REV	DATE	DESCRIPTION
△	10/13/15	SHEET ADDITIONS
△	02/03/16	MODIFICATIONS FOR CHANGED DECK TYPE

PROJECT NAME: WAITSFIELD

PROJECT NUMBER: BF 013-4(39)

ABUTMENT NO. 1 PLAN

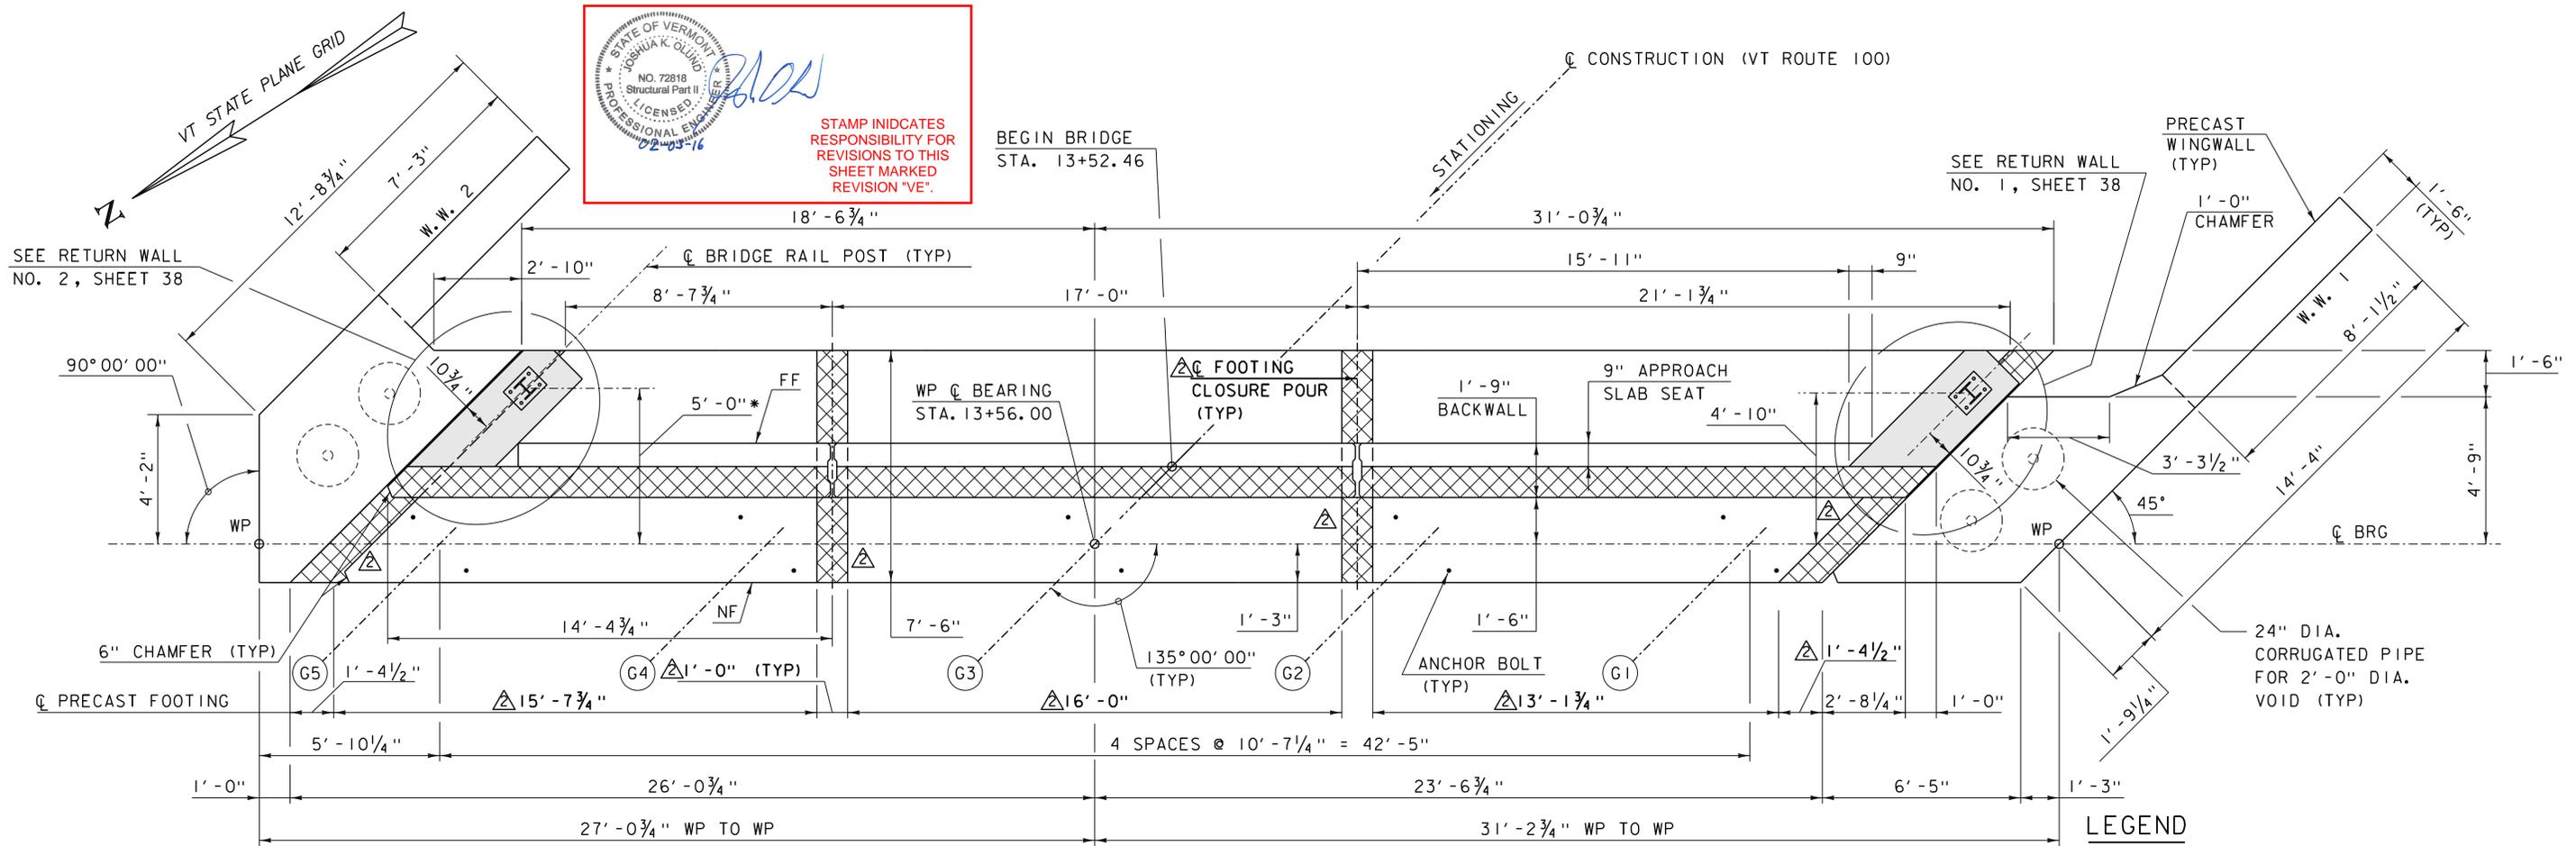
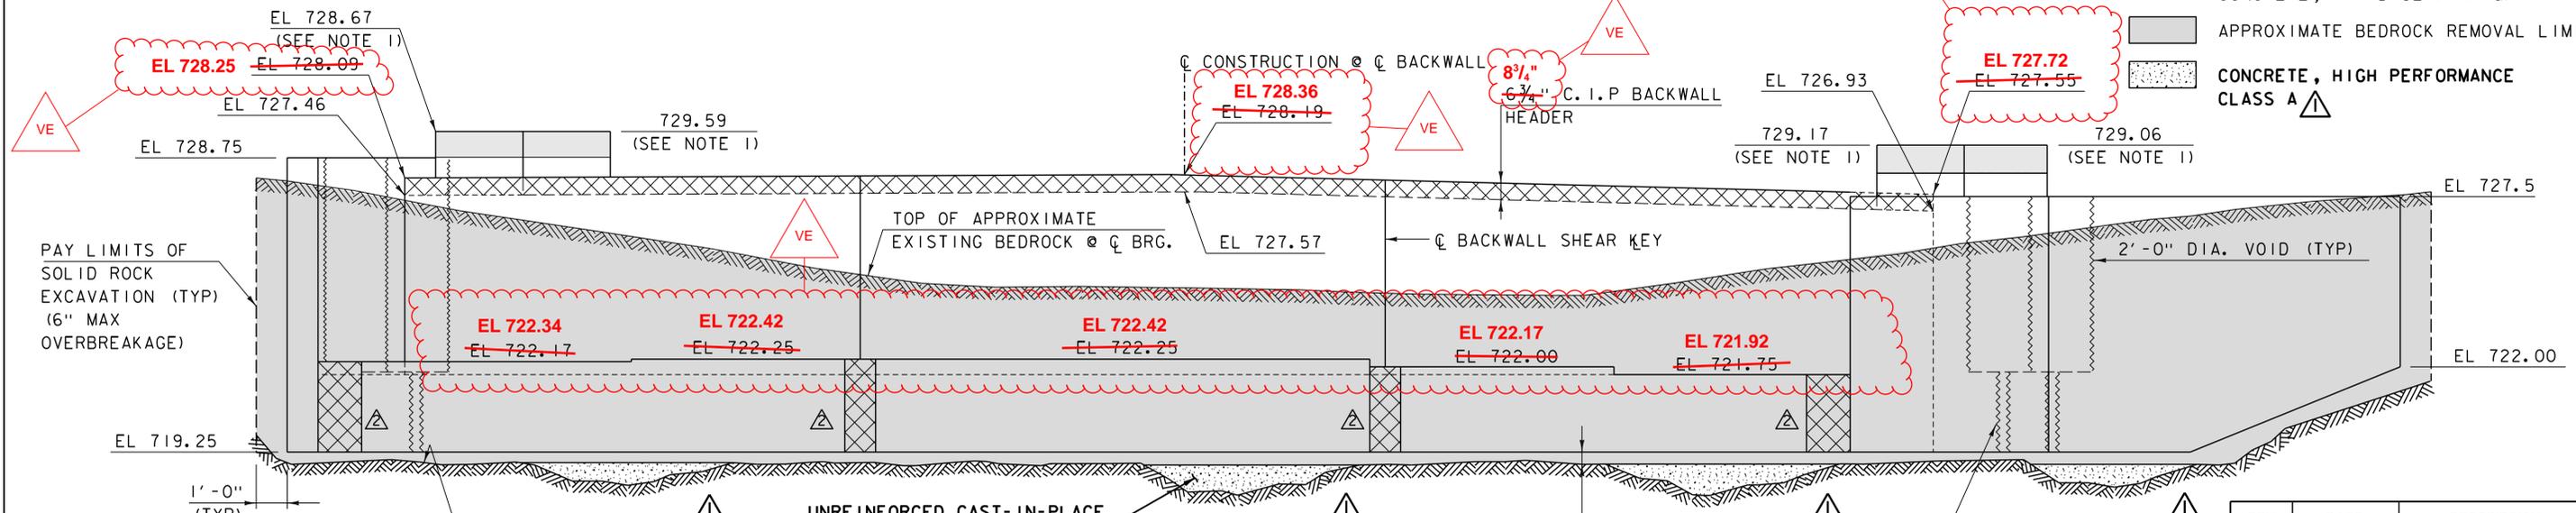
REV	DATE	DESCRIPTION
▲	10/13/2015	SUBFOOTING REVISION
▲	10/13/2015	FOOTING CLOSURE POUR & ELIMINATE POST TENSIONING

REV	DATE	DESCRIPTION
▲	02/03/16	REVISED ELEVATIONS FOR DECK CHANGE
